4. TITLE AND SUBTITLE
FINAL DECISION DOCUMENT, NORTHWEST BOUNDARY SYSTEM, ROCKY MOUNTAIN ARSENAL
LONG TERM IMPROVEMENTS, INTERIM RESPONSE ACTION, VERSION 1.0

**FINAL DECISION DOCUMENT
NORTHWEST BOUNDARY SYSTEM
ROCKY MOUNTAIN ARSENAL
LONG-TERM IMPROVEMENTS
INTERIM RESPONSE ACTION
OCTOBER 1991
CONTRACT NO. DAAA15-88-D-0022
VERSION 1.0**

STATE COMMENTS ON PROPOSED DECISION DOCUMENT, NORTHWEST
BOUNDARY SYSTEM, ROCKY MOUNTAIN ARSENAL
LONG-TERM IMPROVEMENTS, INTERIM RESPONSE ACTION,
JUNE 1991

SHELL COMMENTS ON THE PROPOSED DECISION DOCUMENT
FOR THE NORTHWEST BOUNDARY SYSTEM
LONG-TERM IMPROVEMENTS
INTERIM RESPONSE ACTION
JUNE 1991

Figure 2-2

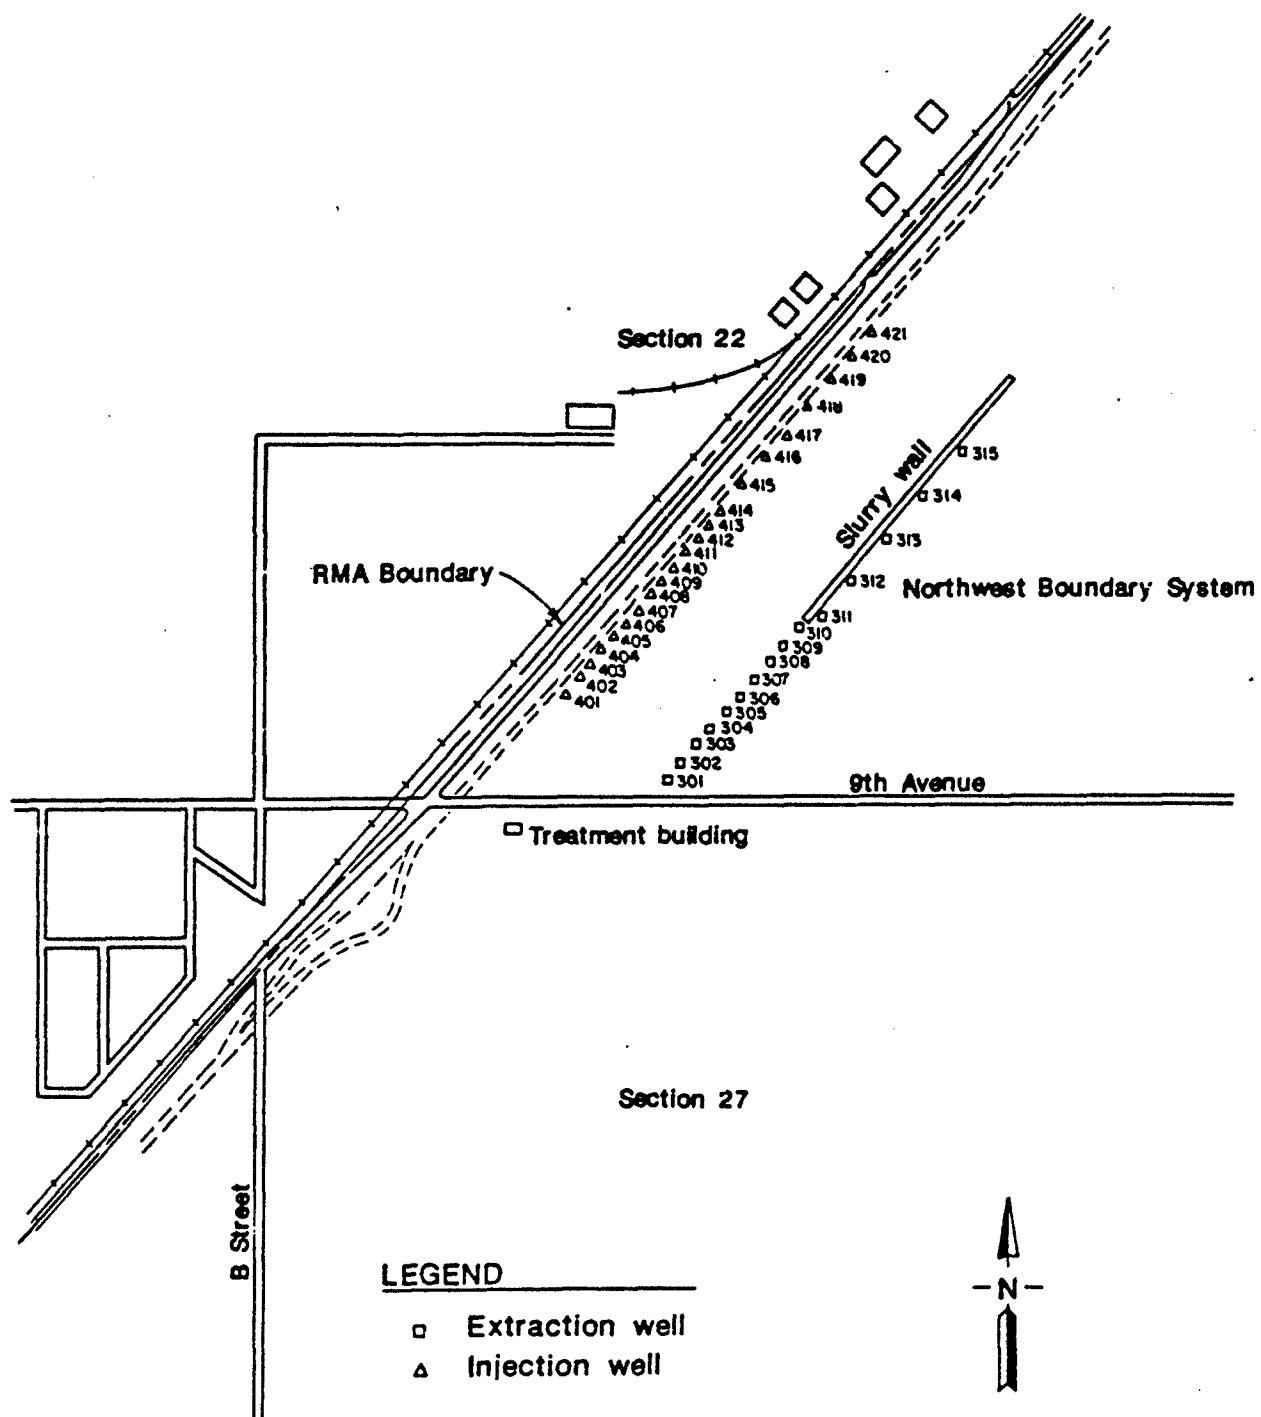
Page 6-1, Section 6.0. In order to support the preferred alternative selected in this Decision Document, please provide in this document a single site vicinity map which clearly depicts the monitoring wells proposed for sampling, the capture and recharge wells, the unconfined water table, and the contaminant plume which this IRA improvement intends to capture.
